Docket Item #6
BAR CASE # 2017-00095

ISSUE: Certificate of Appropriateness for Alterations

LOCATION: 320 South Pitt Street

STAFF RECOMMENDATION

Figure 4: the side (north) elevation of the ell and the rear (east) elevation of the main block. These four windows are not visible from any public right-of-way.

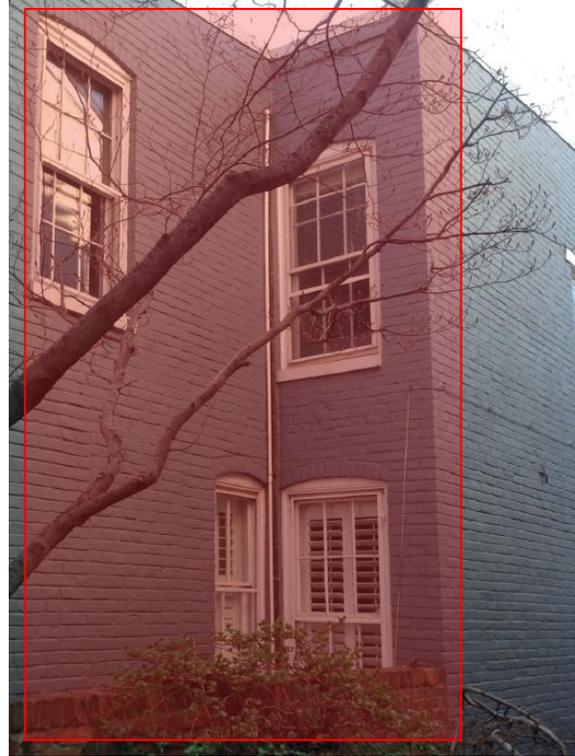
The west and north elevations of the historic main core are clearly visible from South Pitt Street while the north elevation of the ell is partially visible from South Pitt Street: only one of the three windows on the north elevation of the rear ell is visible from the public right-of-way. [Figures 1 and 2] The rear (east) elevation of the ell is visible from Wolfe Street. [Figure 3] However, the rear (east) elevation of the main block is not visible from any public right-of-way; therefore, the replacement of two windows on the side (north) elevation of the ell and two windows on the rear (east) elevation of the main block does not fall under BAR purview. [Figure 4] Hence, this application will only consider 9 of the 13 requested window replacements.

As the east elevation of the main block is not visible from any public right-of-way [see Figures 3 and 4], the two windows on that portion of the elevation cannot be reviewed by the BAR. However, the one window on the second story of the rear ell's east elevation is visible from Wolfe Street and its replacement must be reviewed by BAR. Again, BAR staff believes that, although the ell has the same date of construction as the main block, the hierarchy of elevations places this rear elevation on a rear ell as the lowest in importance; and at such a distance, and in the middle of the block, BAR staff believes the use of aluminum cladding would not be discernable by the casual passerby. Therefore, BAR staff recommends that if a modern material – such as aluminum clad wood – can be proven to simulate *the appearance of wood* convincingly from such a distance; with the same rail, stile and muntin profile, it may be beneficial to consider replacement of this window with a non-historic material in this particular instance.

Figure 7 (above): the north elevation of the ell has a two-over-two wood window that may be original, but it is not visible from a public ROW.

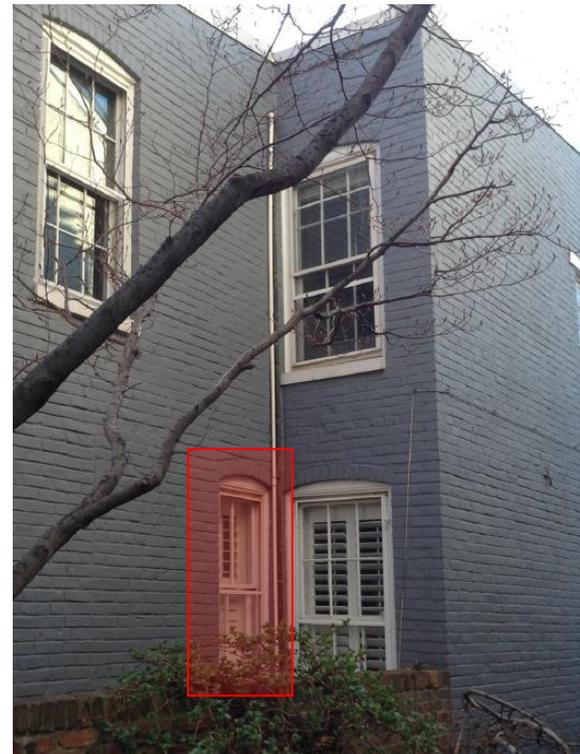
As previously mentioned, only one of the three windows on the north elevation of the ell is visible from South Pitt Street; therefore, the two which are not visible [see Figure 4] are not within BAR’s purview. Keeping that in mind, BAR staff would like to point out that one of the two windows on the north elevation of the ell is (presumably) the only extant original window in situ. [Figure 7] Although BAR staff has not inspected this window from within the house, it is the only two-over-two window on the entire residence. Ideally, from the standpoint of preservation, the applicant would retain and repair this lone example of an original window (if BAR staff were able to determine that it is, indeed, original). However, as it is not visible from a

public right-of-way, it does not fall within the BAR's mandate and the applicant is free to replace windows that are not visible from public right-of-ways in any material of choice.
